July 31, 2025

**Re: Permit No. M-1980-244; Cripple Creek & Victor Gold Mining Company; Cresson Project; Technical Revision 149 – VLF2 Proposed Vibrating Wire Piezometer Installation**

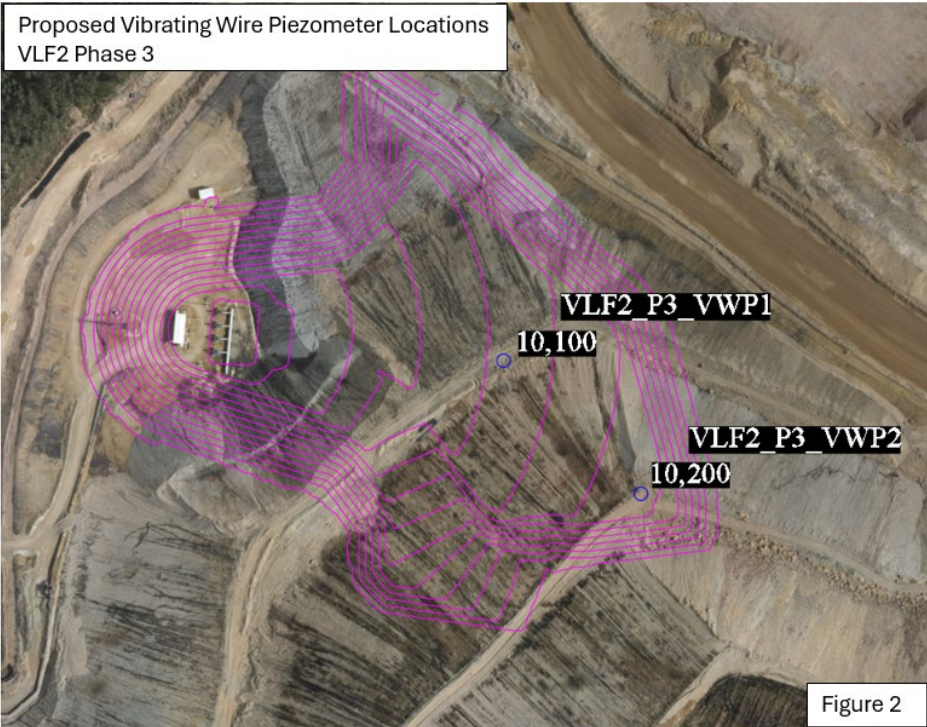
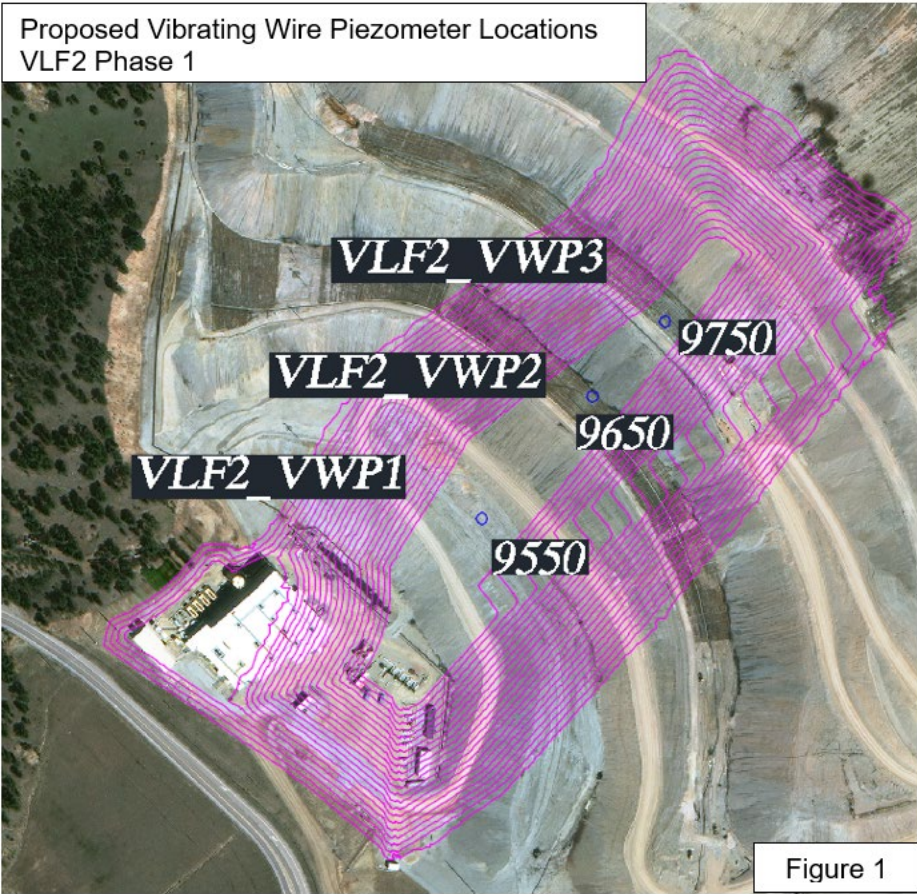
CC&V is proposing the installation of Vibrating Wire Piezometers (VWP) that will be installed on VLF2 Phase 1 and Phase 3 as shown in Figures 1 and 2 (see below).

To ensure no damage to the liner during piezometer installation, the following procedure will be followed.

- **Drill to 200 ft above liner**
  - Conduct a downhole deviation survey.
  - Evaluate results.
- **Drill to 100 ft above liner**
  - Conduct a downhole deviation survey.
  - Evaluate results, terminate drilling if deviation is unacceptable, or continue.
- **Tentatively drill to 60 ft above liner**
  - Conduct downhole deviation survey.
  - Evaluate results, terminate, or proceed.
- **Tentatively drill to 40 ft above liner**
  - Conduct downhole deviation survey.
  - Evaluate results, terminate, or proceed.
- **Tentatively drill to 30 ft above liner**
  - Conduct downhole deviation survey.
  - Terminate drilling.
